Addendum No. 2

**ITB No. 25-16
SPLOST 5C RESURFACING PROGRAM**

June 18, 2025

DATE	REVISIONS	DATE	REVISIONS	TYPICAL SECTIONS MAJOR ROADS

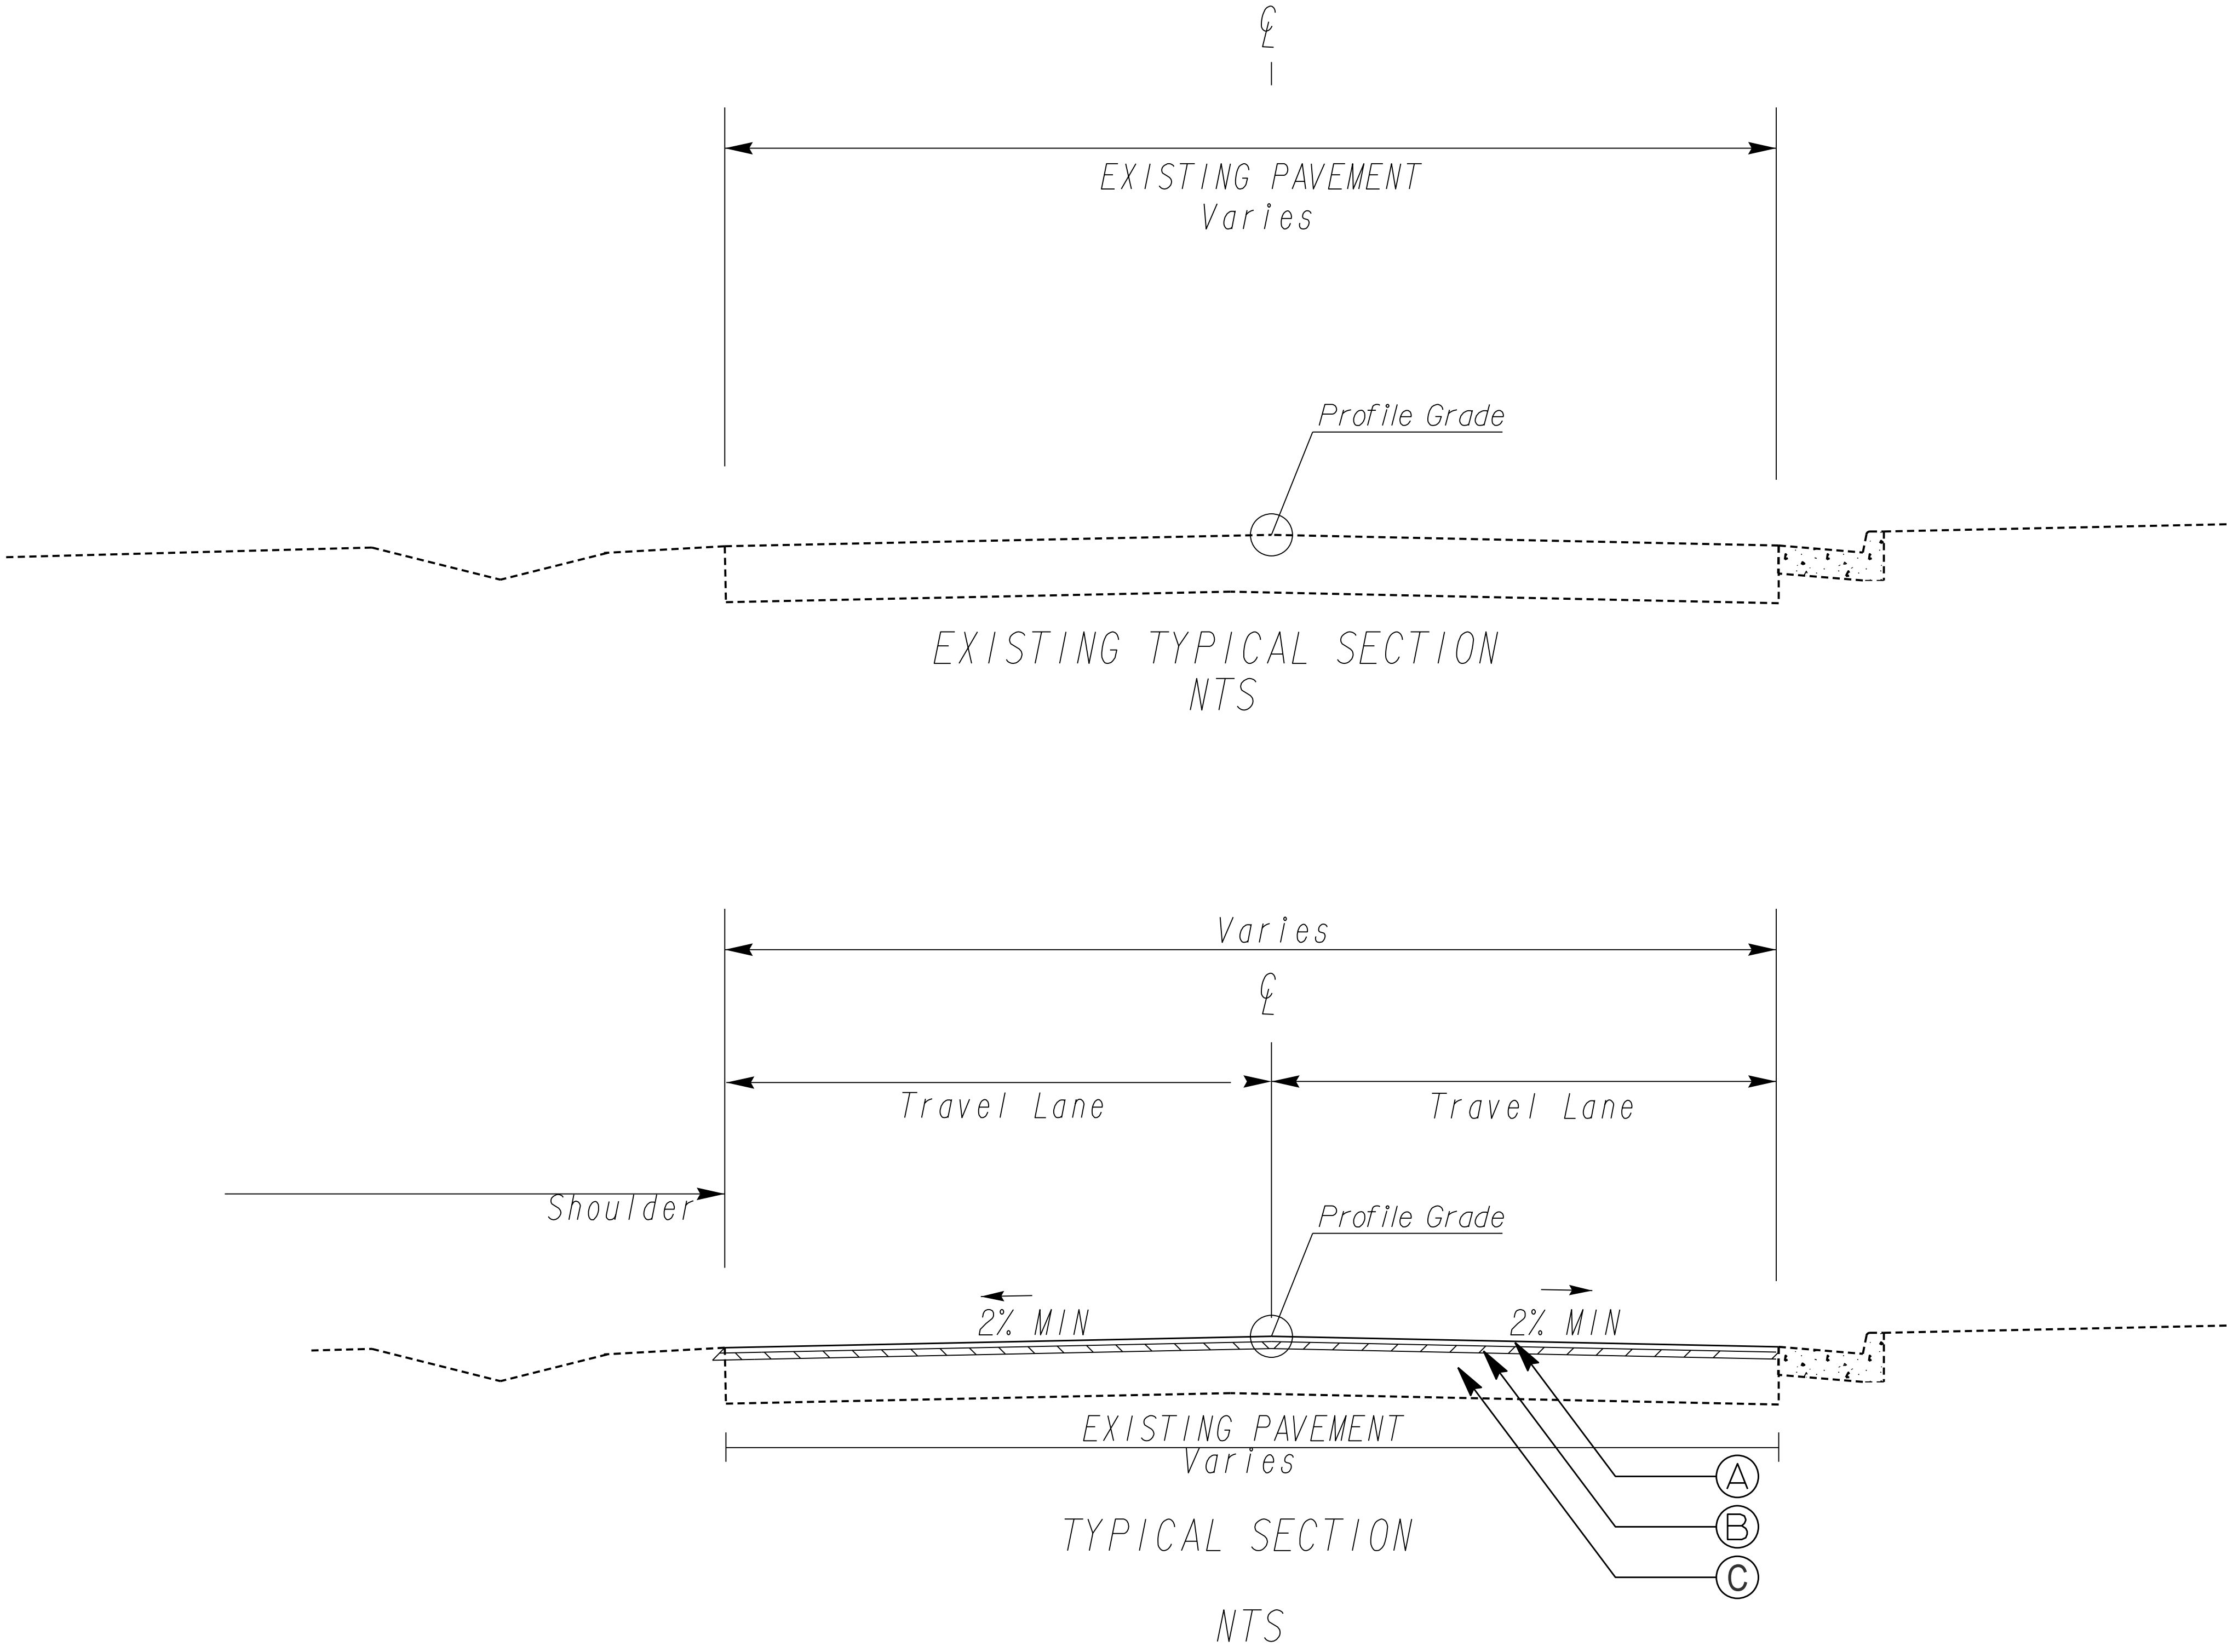
B. Question: The roads on the detail page 118 show a list of roads that do not look to be on this project. Can you clarify if they are on the project or not?

C. Question: On the detail page 118, the detail shows mill @ 3.5", then 2" 19mm and 1.5" of 12.5mm. Is this the correct specification?

Answer: Roads names have been removed. See attached.

Answer: This question will be addressed during the pre-bid conference.
